**TO:** Jeanne Shaffer, Groundwork Entitlement Services, LLC  
**FROM:** BrieAnna Simon, Associate Planner  
**DATE:** March 13, 2020  
**SUBJECT:** SP19-062, Site Plan, Horseshoe Ridge Block 1 Lot 2 - Multi-Tenant Commercial Review Comments v3

# PARKER MIXED-USE RETAIL

LOT 2, BLOCK 1, HORSESHOE RIDGE SUBDIVISION 1ST AMENDMENT  
 A PARCEL OF LAND LOCATED IN THE SE 1/4 OF SECTION 28, TOWNSHIP 6 SOUTH, RANGE 66 WEST OF  
 THE 6TH PRINCIPAL MERIDIAN  
**SITE PLAN REVIEW**

**1 PHOTOMETRIC SITE PLAN**  
scale: 1"=20'-0"  
NORTH

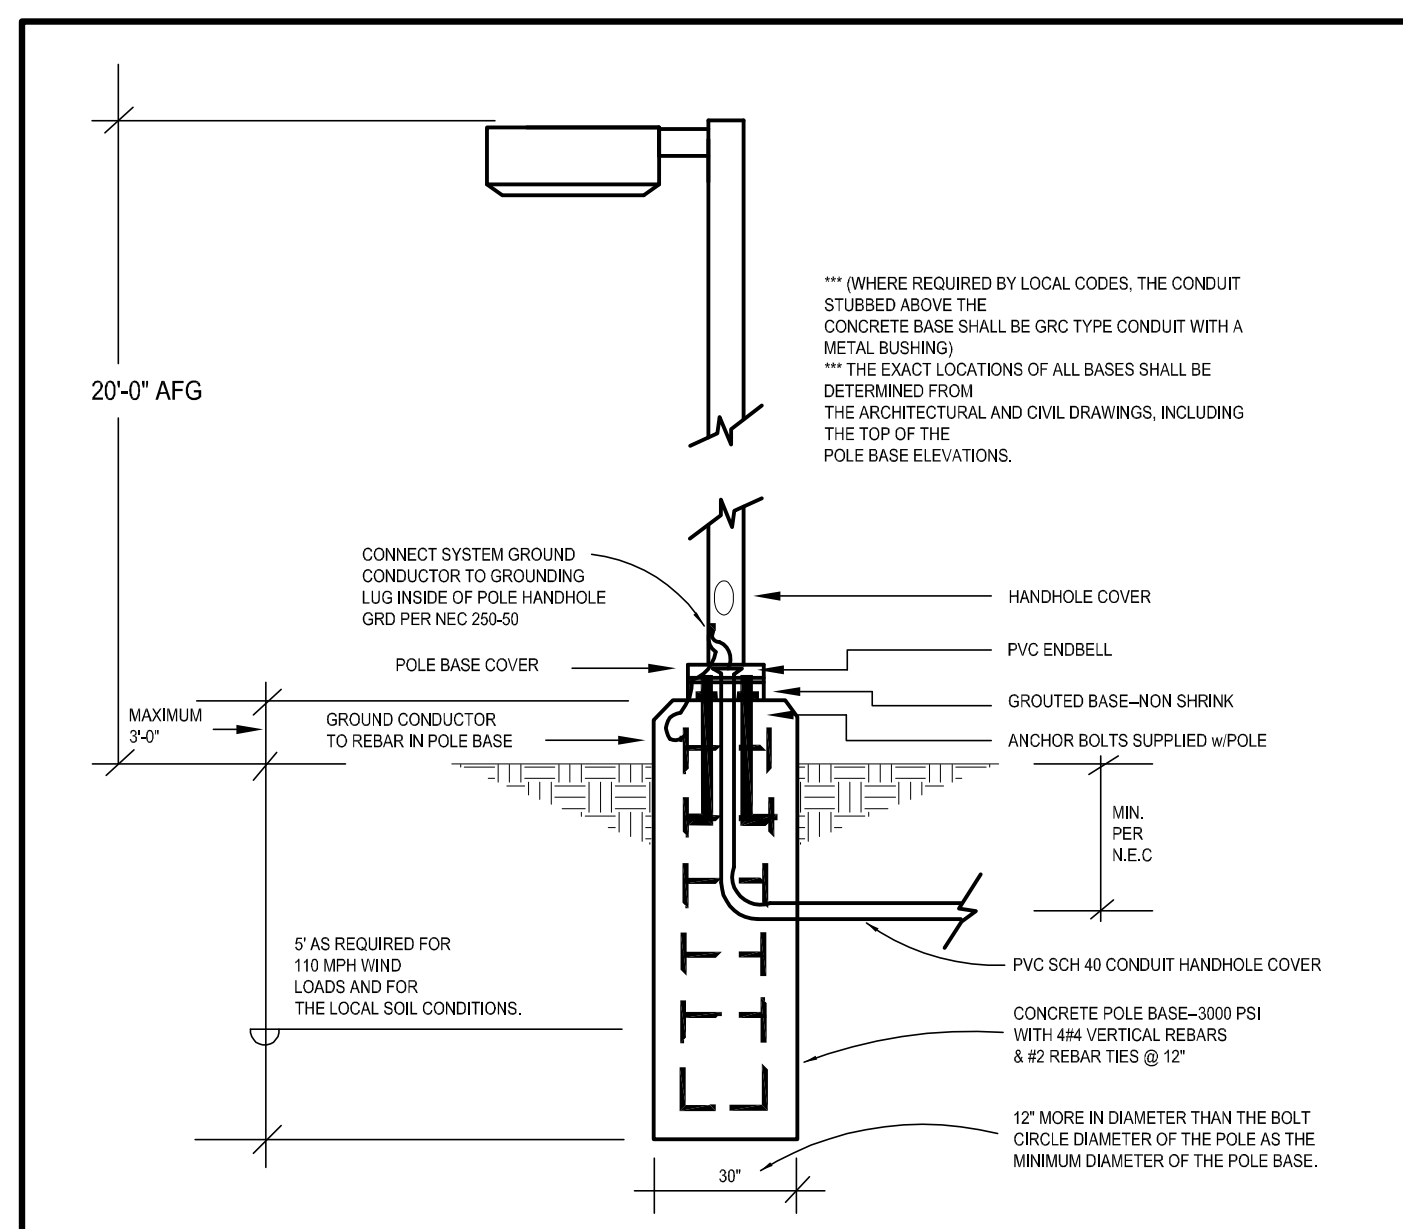
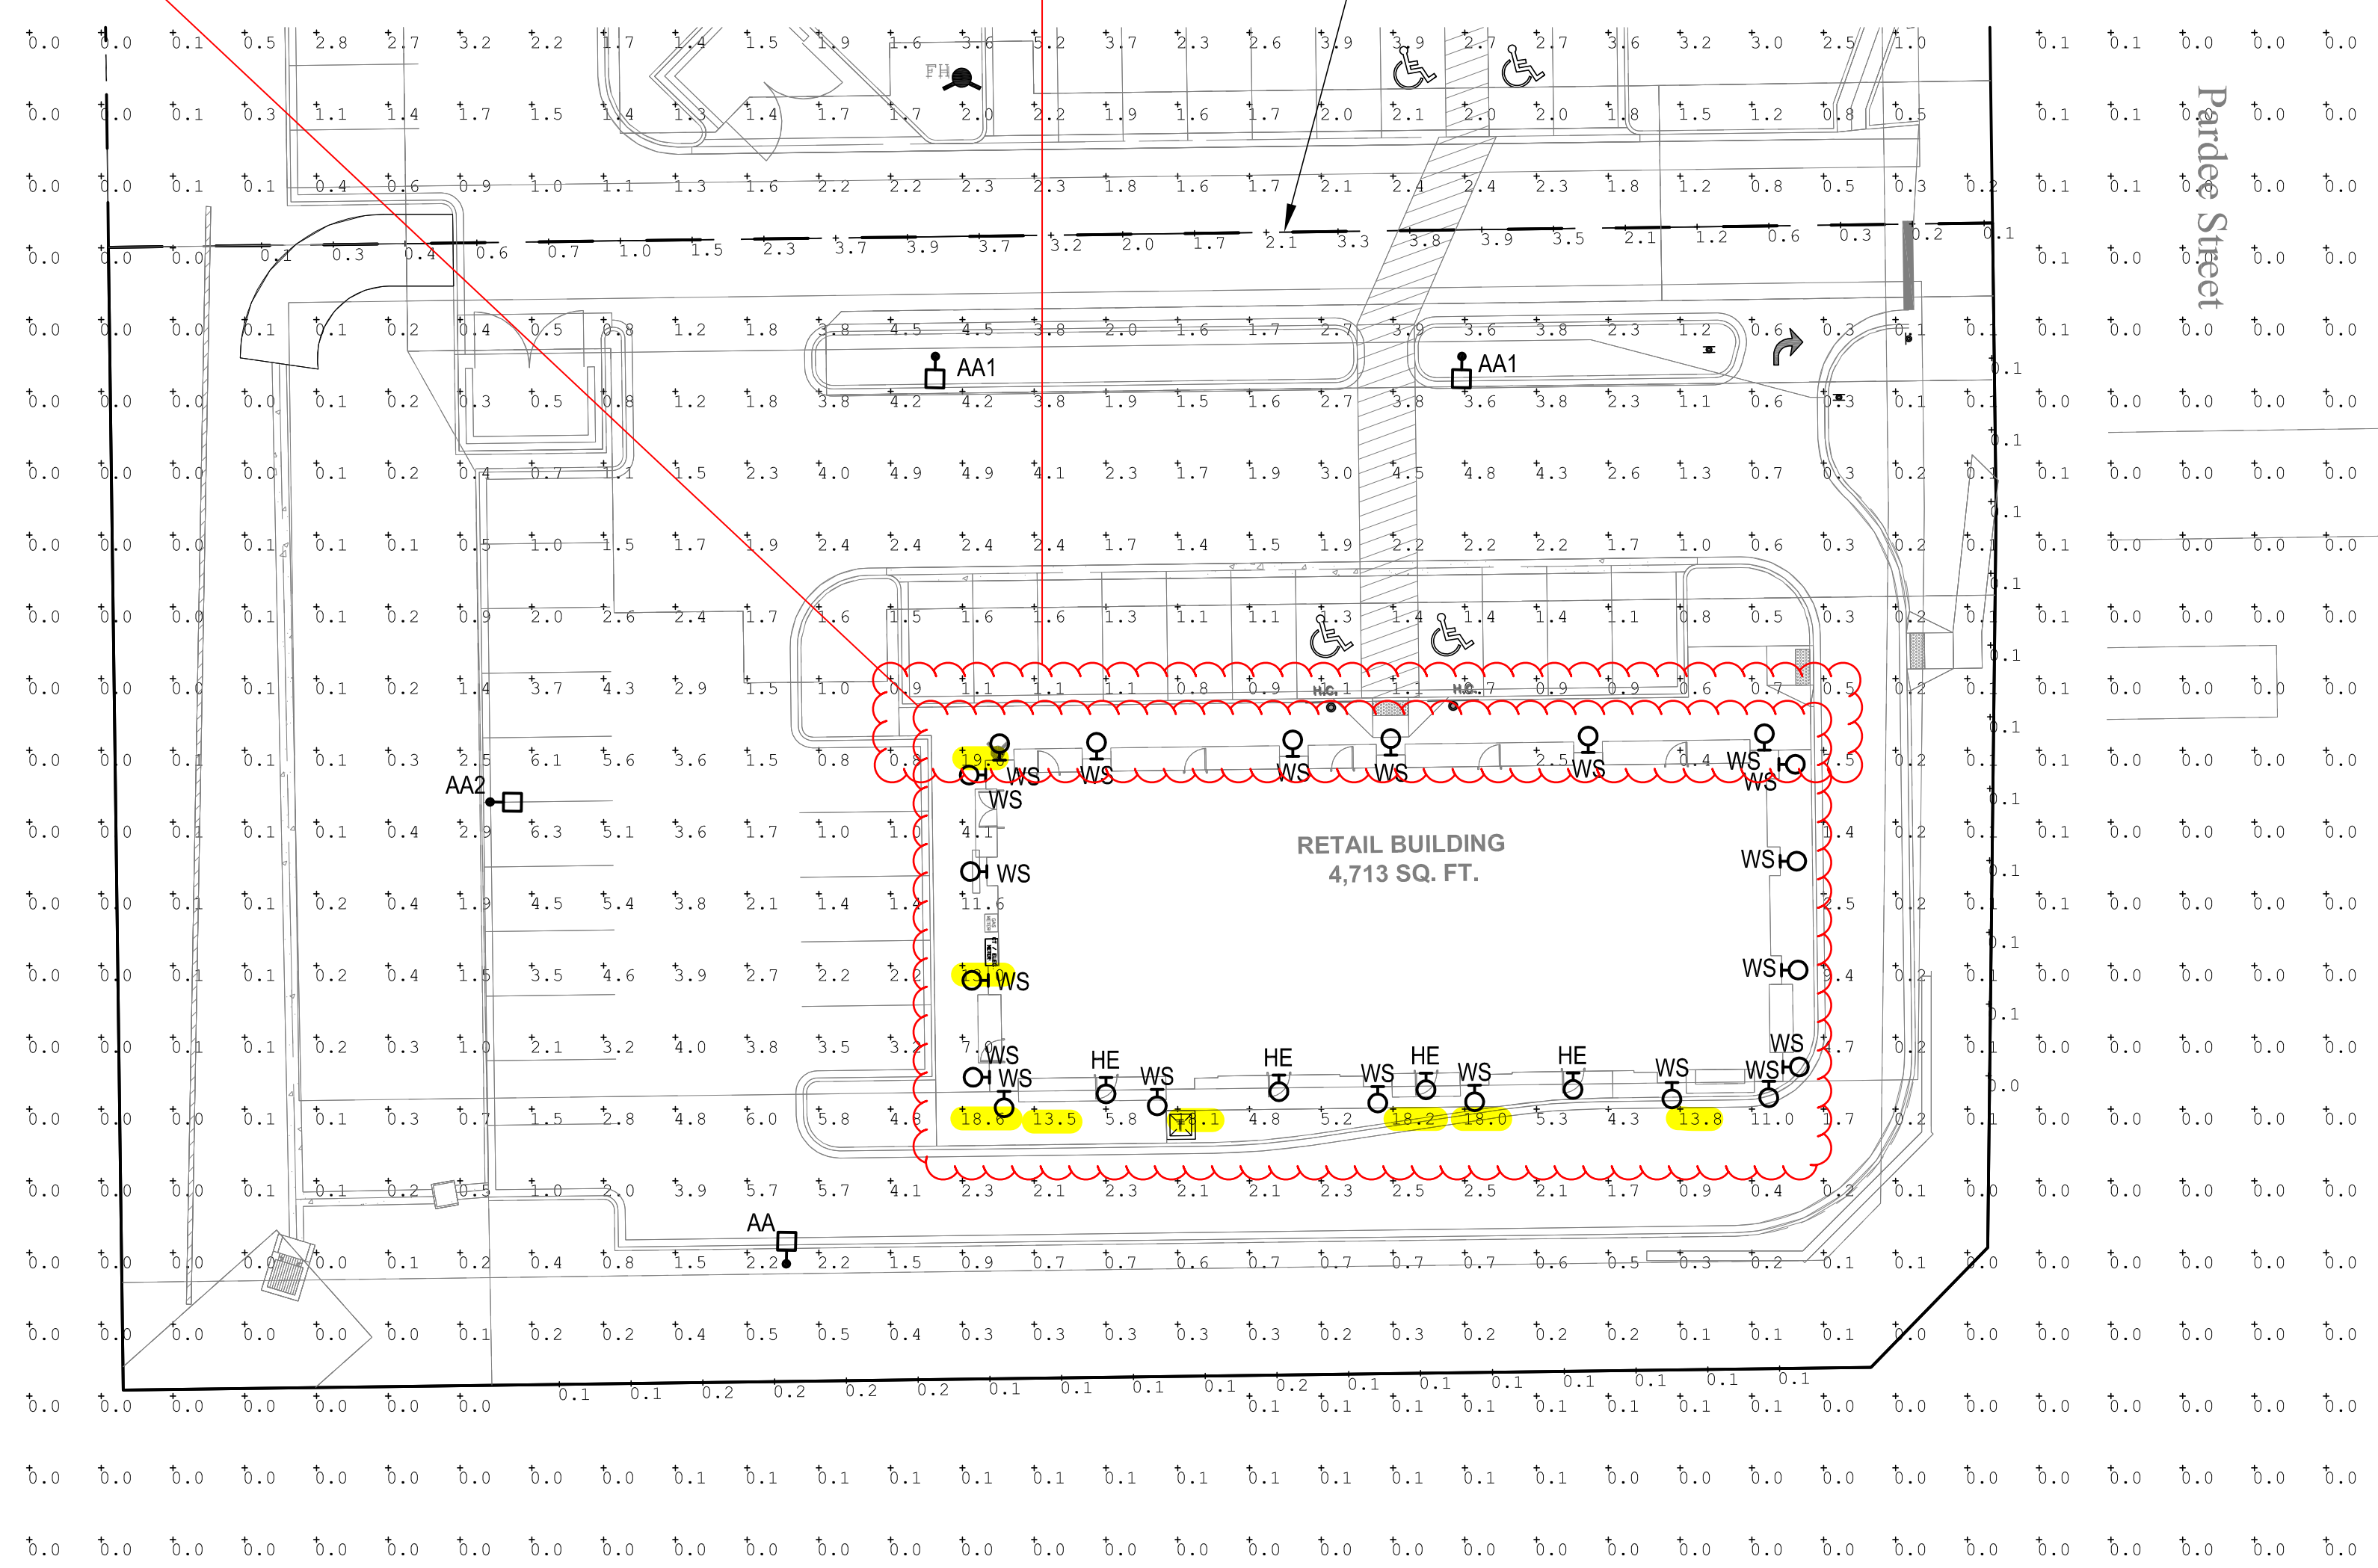
Per Section 13.10.140 (e)(14) The maximum illuminance on any residential or nonresidential site (not including any site with a qualifying principal display area) is twelve point zero (12.0) foot-candles, maximum installed illuminance. Please adjust accordingly.

Provide the foot candles along the pedestrian walk way.

Per Section 13.10.140 for pedestrian safety and orientation, medium activity lots the maximum Uniformity Ratio (average to minimum) is 3:1. Please adjust accordingly.

Per Section 13.10.140 for pedestrian safety and orientation, medium activity lots the maximum Uniformity Ratio (maximum to minimum) is 10:1. Please adjust accordingly.

THE LIGHT LEVELS EXCEED AT THE PROPERTY LINE FOR THE SHARED ACCESS ISLE ONLY TO PROVIDE ADEQUATE LIGHTING FOR VEHICLE AND PEDESTRIAN SECURITY BETWEEN BOTH PROPERTIES. ALONG THE PROPERTY LINE, THE MINIMUM FOOT CANDLE PROVIDED IS 0.1 AND MAXIMUM FOOT CANDLE PROVIDED IS 3.9. THIS MEETS THE MAXIMUM ALLOWED ILLUMINANCE FOR NON-RESIDENTIAL SITE

LS 1.0

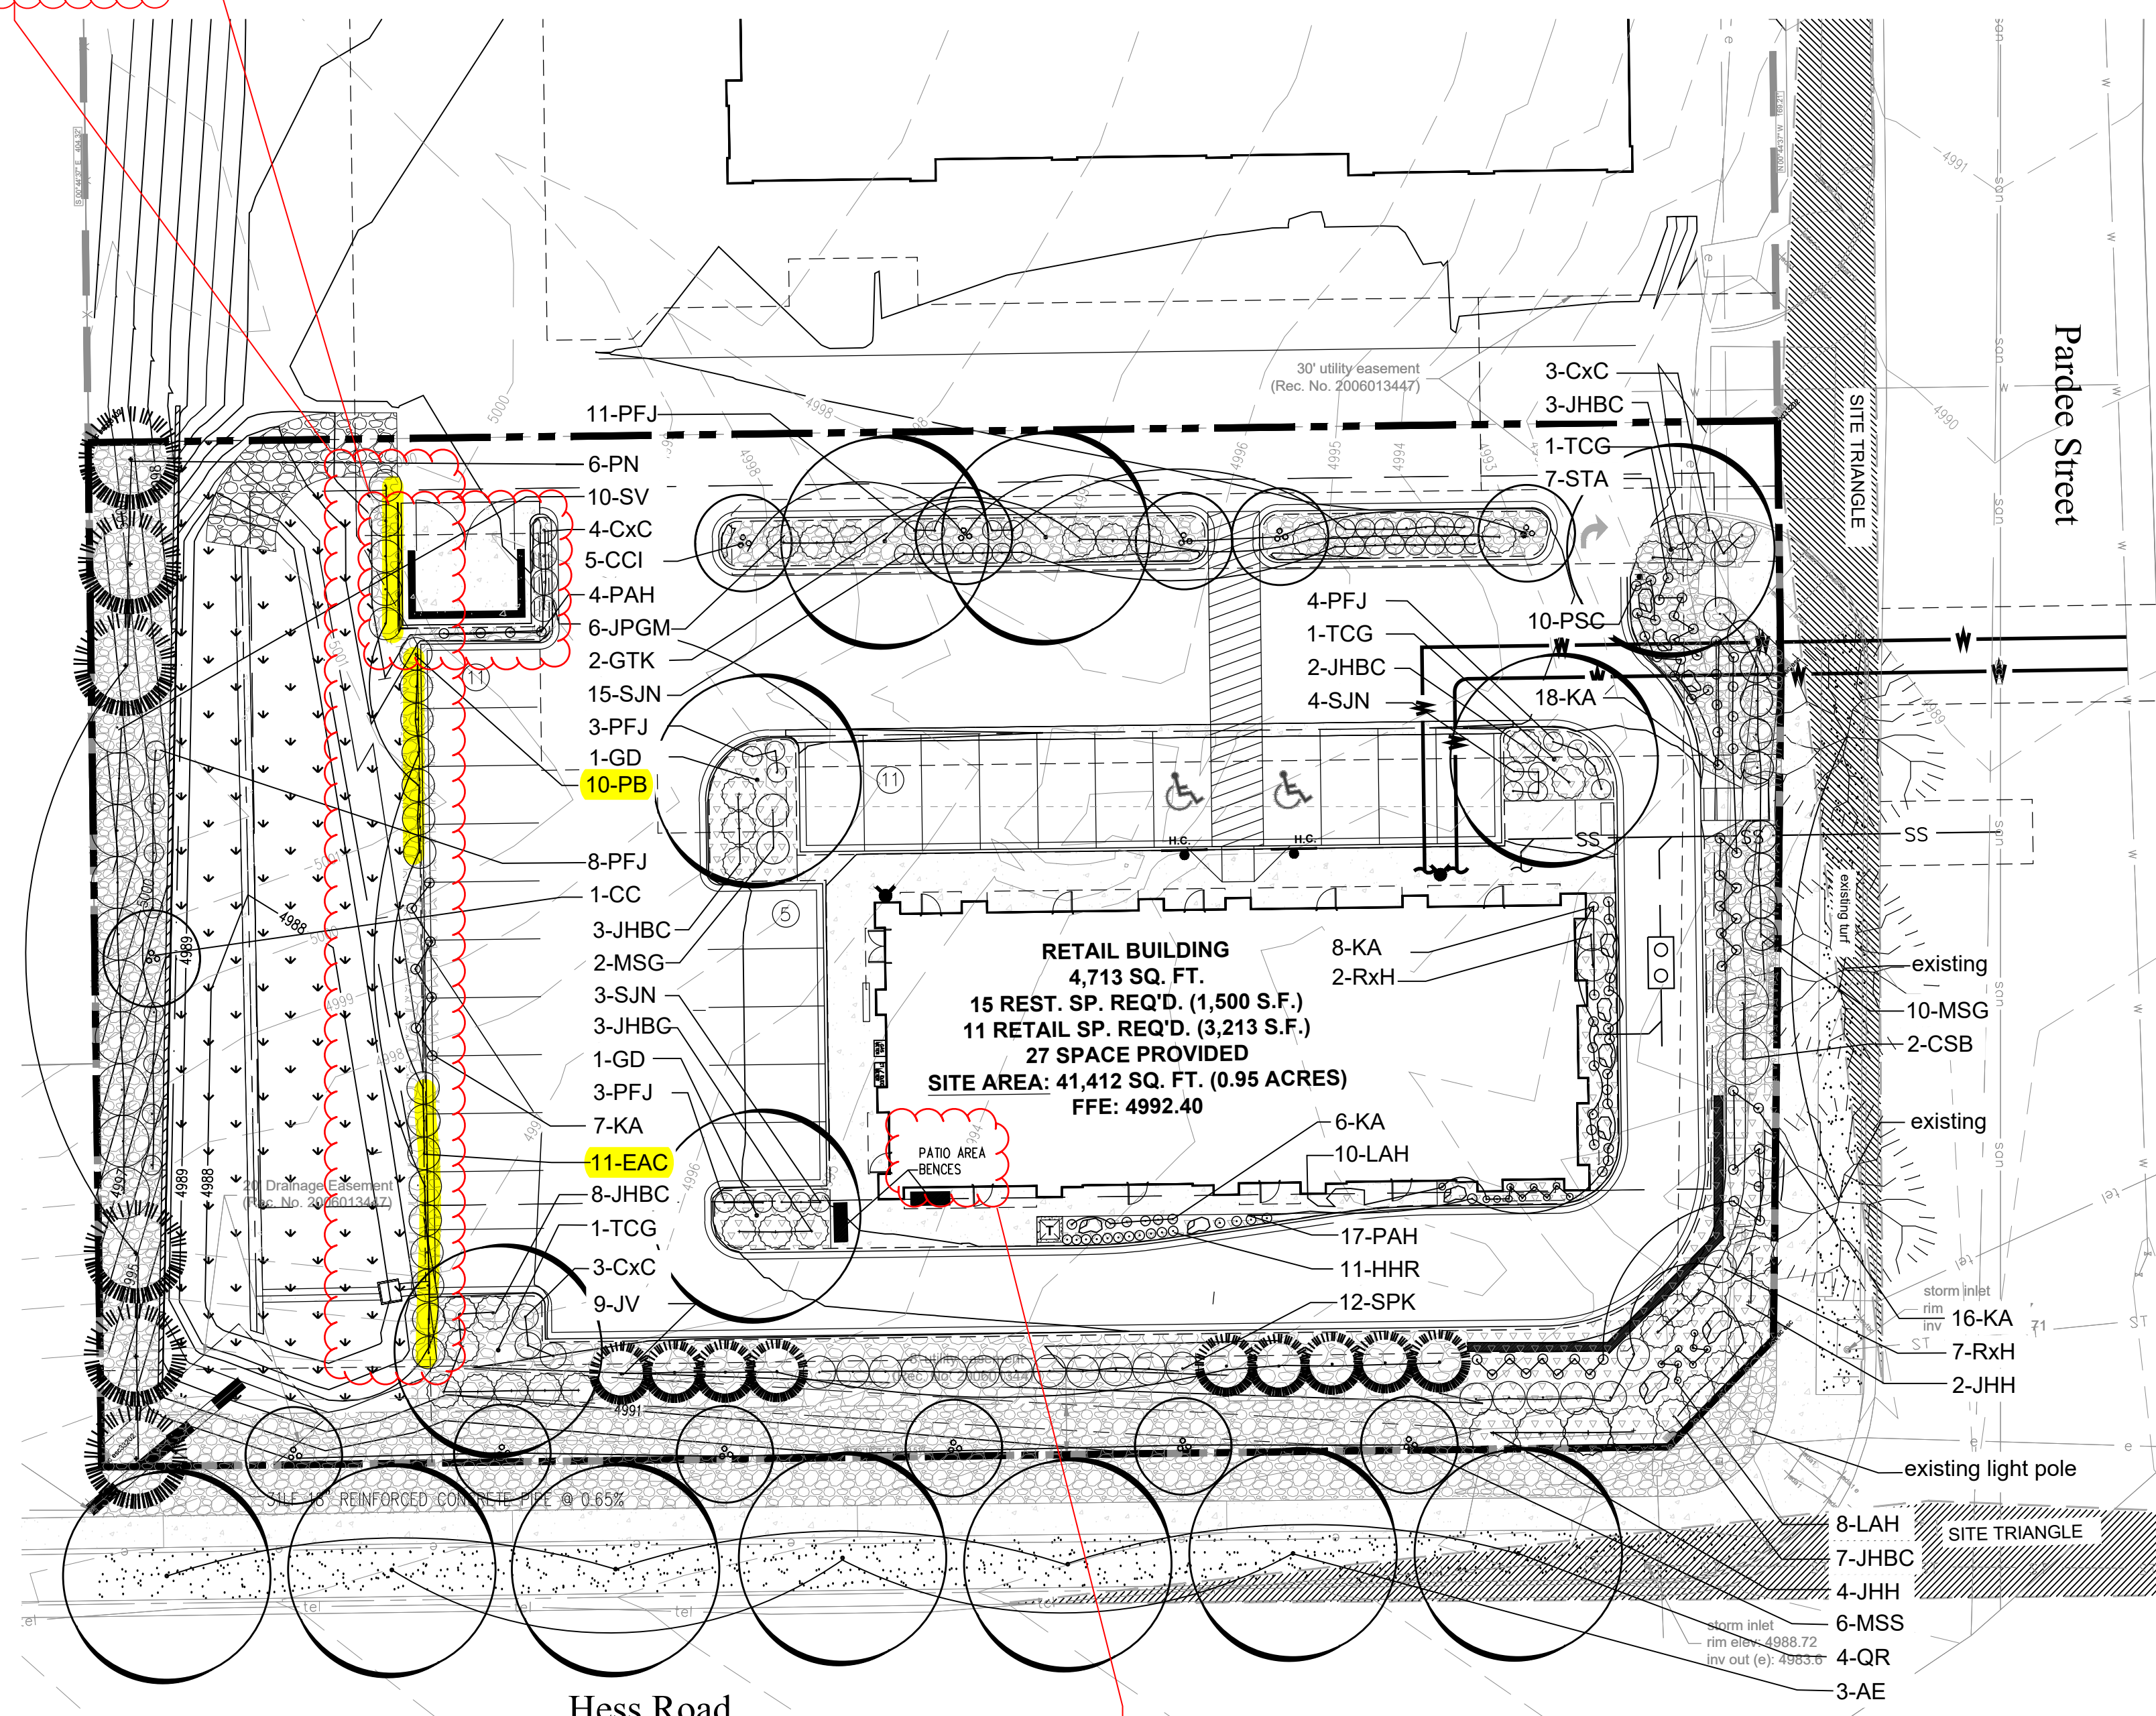
Please provide more information on how the shown landscaping meets the minimum height requirement. Landscaping to the east is not labeled, PAH perennials to the south are 2 feet in height and CxC shrubs to the west are 3 feet in height.

What are these shrubs? The labeling and number of plantings do not add up.

Add these to the site plan (page 2).
